SAFETY EVALUATION

Related to the
U.S. SFR Owner, LLC
Construction Permit Application for
the Kemmerer Power Station Unit 1

Completed: November 2025

Figure 2.6-5: Comparison of the applicant's horizontal GMRS (red curve) to the staff's horizontal GMRS (blue curve).

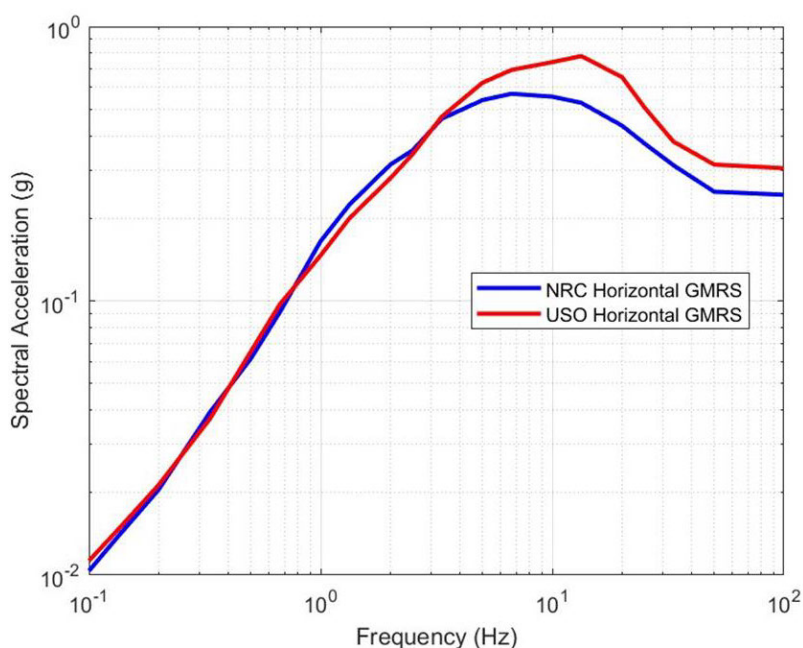
As described in SE section 2.6.2.3, the staff performed a confirmatory site response analysis. Using these results, along with the methodology of ASCE/SEI 43-19, the staff calculated a horizontal GMRS and compared it with the applicant's horizontal GMRS (see SE figure 2.6-5). Despite the differences in site response methodology with respect to the implementation of the

The staff determined that the applicant's use of ASCE/SEI 43-19 to develop the GMRS for Seismic Design Category 5 is acceptable as it is consistent with the guidance in DANU-ISG-2022-02. According to appendix A to DANU-ISG-2022-02, SSCs designed to this design category would generally meet the requirement in 10 CFR Part 50 appendix S. Furthermore, the staff determined that the GMRS is an appropriate SSE as it satisfies the SSE criteria set forth in 10 CFR 50, appendix S, paragraph IV.a.1.i.

Figure 2.6-6: Comparison of the applicant's vertical GMRS (red solid curve) to the staff's vertical GMRS (blue solid curve). The applicant's horizontal GMRS is depicted by the red dashed curve.

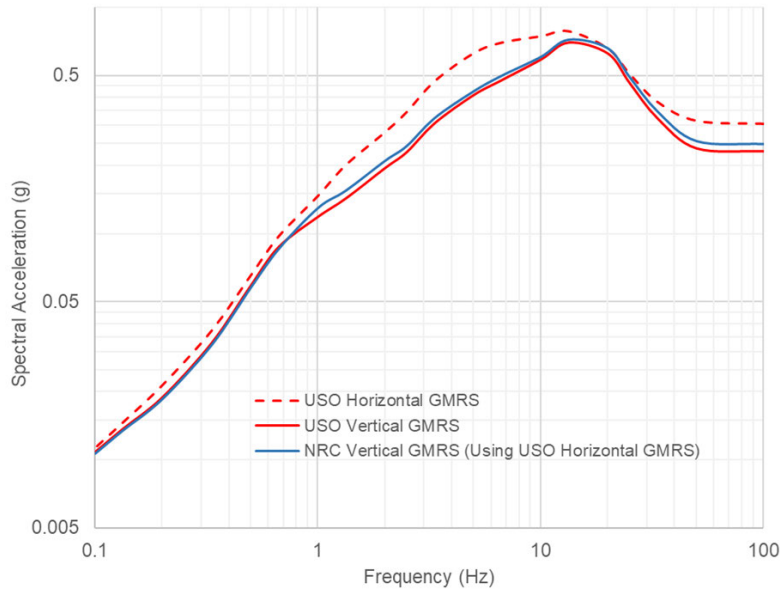
The staff also reviewed USO's V/H ratios and resulting vertical GMRS. The staff concluded that the use of Gülerce and Abrahamson (2011) is appropriate to develop V/H ratios for the KU1 site and significant seismic sources the site based on the 10^{-4} and 10^{-5} hazard deaggregation at 10 Hz (i.e., appropriate for shallow crustal earthquakes in active tectonic regions). The also staff performed a confirmatory calculation and found that the mean results are comparable to USO's mean results provided in table 15 of the GMRS report. SE figure 2.6-6 provides a comparison of these results; the differences are less than 9 percent difference across the entire frequency range.
